**STAFF RECOMMENDATION**  
**1514, 1516 & 1518 Edgehill Avenue**  
**December 16, 2020**

**Application:** Final SP Review—Infill  
**District:** Edgehill Neighborhood Conservation Zoning Overlay  
**Council District:** 19  
**Base Zoning:** SP  
**Map and Parcel Number:** 10501022500, 10501022600 & 10501022700  
**Applicant:** David Brawner, Pfeffer Torode Architecture  
**Project Lead:** Melissa Sajid, [Melissa.sajid@nashville.gov](mailto:Melissa.sajid@nashville.gov)

# EDGEHILL VILLAGE TOWNHOMES

SITE PLAN

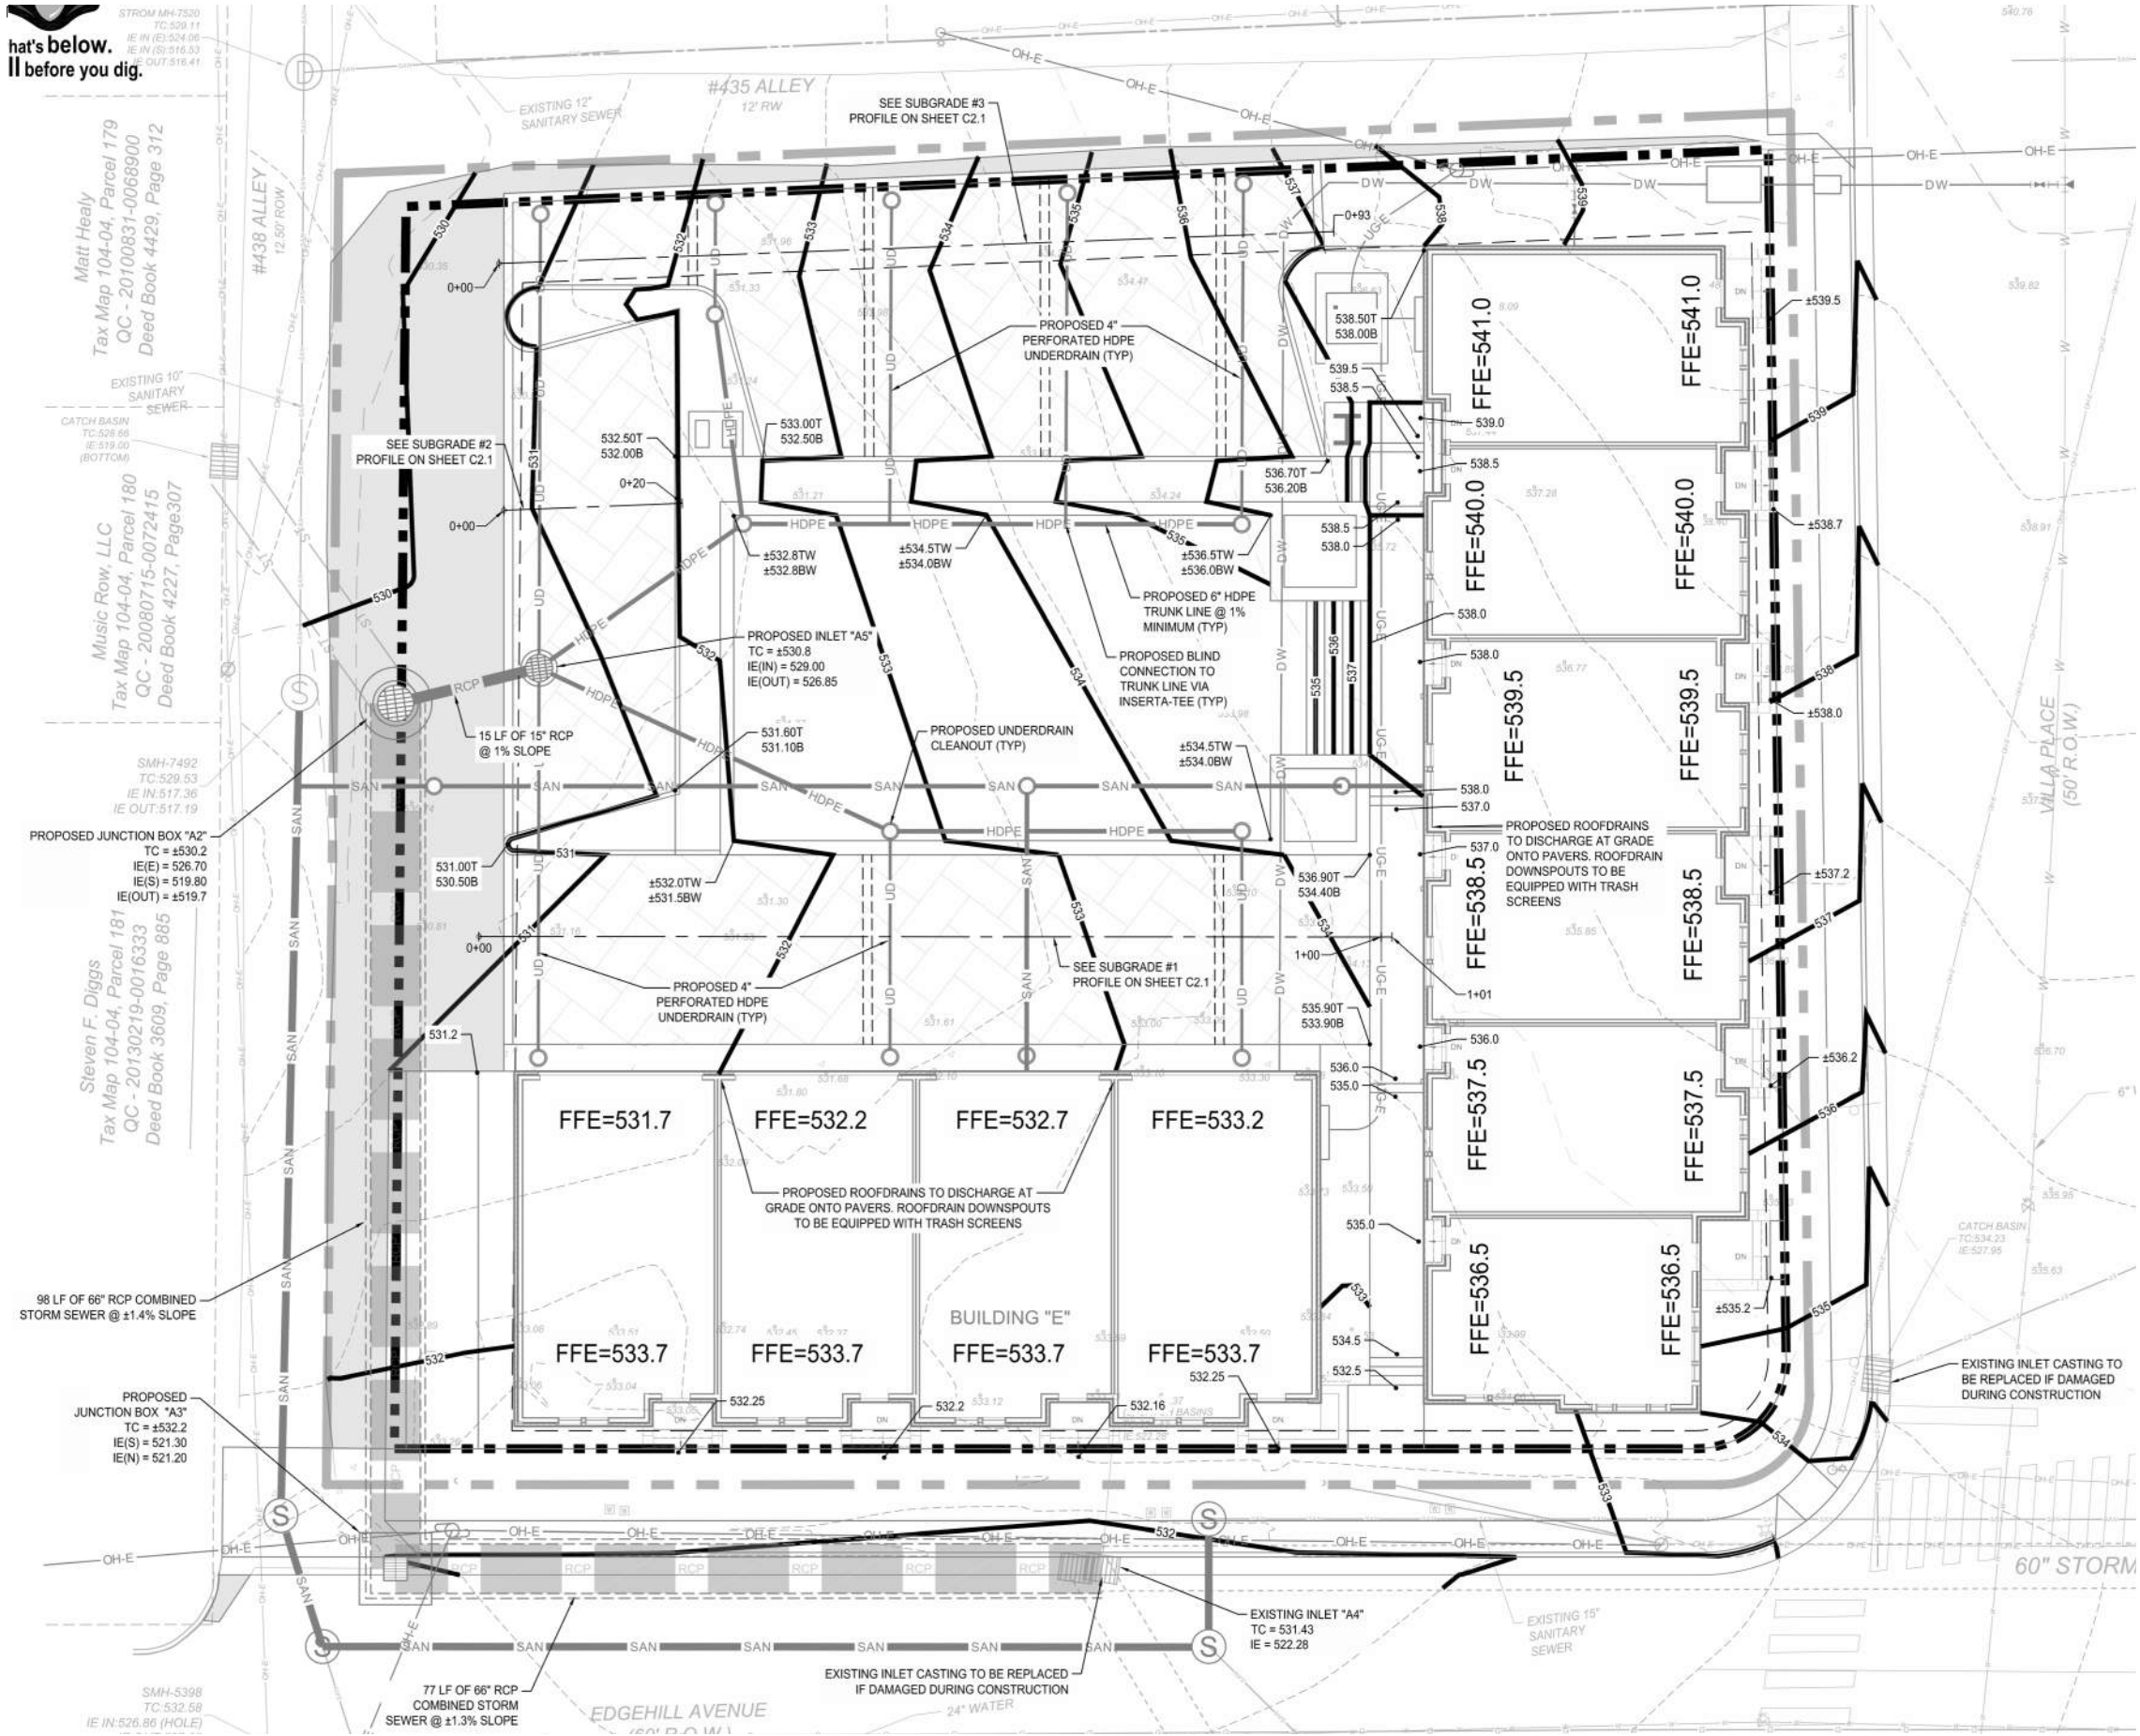
**Setback & Rhythm of Spacing:** The overall siting of the project is consistent with the preliminary approval. The primary wall of the three-story building will be setback two feet (2') from the property line on Edgehill Avenue while the primary wall of the two-story building will be setback four feet (4') from Villa Place. Both buildings included upper-level balconies that extend to the property line.

The preliminary plan included a ten foot (10') sidewalk along both street frontages whereas the final plan shows an eight foot (8') sidewalk along Edgehill Avenue and a five foot (5') along Villa Place, per Public Works.

Staff finds that the proposed setbacks are consistent with the preliminary approval and are appropriate for the site given the context which includes non-single-family structures located directly behind the sidewalk (i.e. White Way).

Staff finds that the project’s setback and rhythm of spacing meet Section III.C. of the Edgehill design guidelines.

ELEVATIONS BLDG E

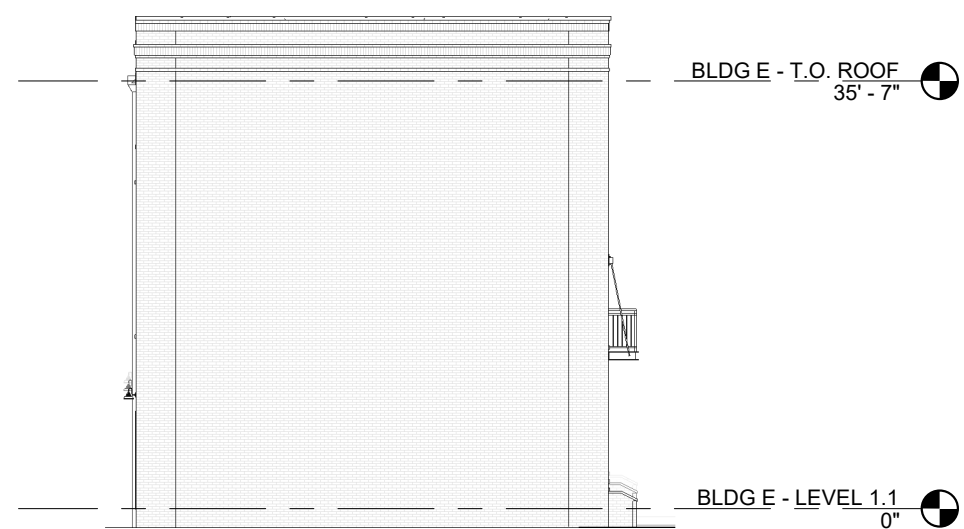
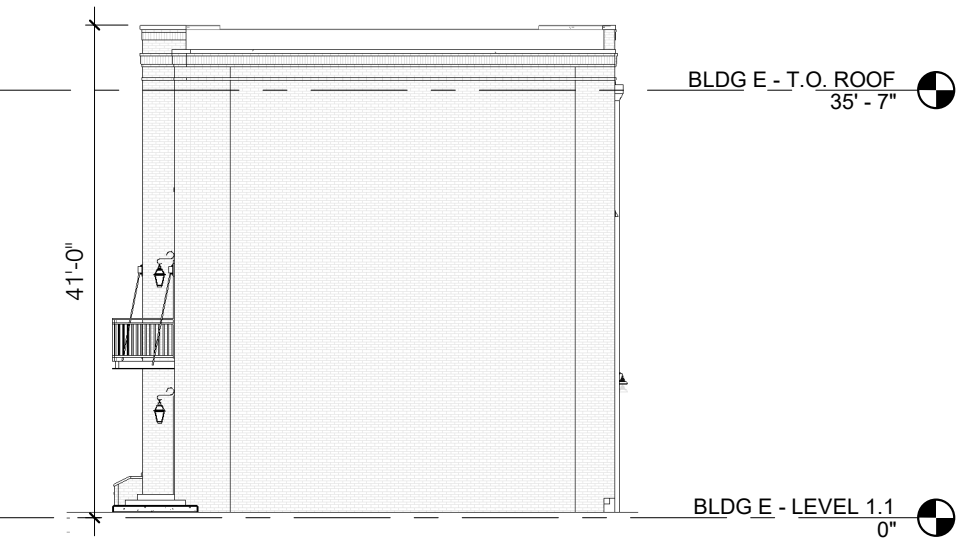
Proportion and Rhythm of Openings: The windows on the both buildings are all generally twice as tall as they are wide, thereby meeting the historic proportions of openings. There are no large expanses of wall space without a window or door opening on the front and rear elevations of both buildings. However, both buildings include side façades that do not include any window or door openings.

For the building oriented to Edgehill Avenue, both side façades are blank, and the north (or right-side) elevation of the building oriented to Villa Place is devoid of openings. Staff finds that this can be appropriate, however, in this case given the orientation of the walls in question. For the Edgehill Avenue building, one blank wall is approximately eleven feet (11') from the rear wall of the building oriented to 16<sup>th</sup> Avenue South, and the other faces a side alley and rear of an office building. For the Villa Place building, the blank wall faces the alley as well as the side of a non-contributing building at 1100 Villa Place. Staff finds that the lack of windows on these façades can be appropriate in this case given the context.

Staff finds the project's proportion and rhythm of openings meet Section III.G. of the Edgehill design guidelines.
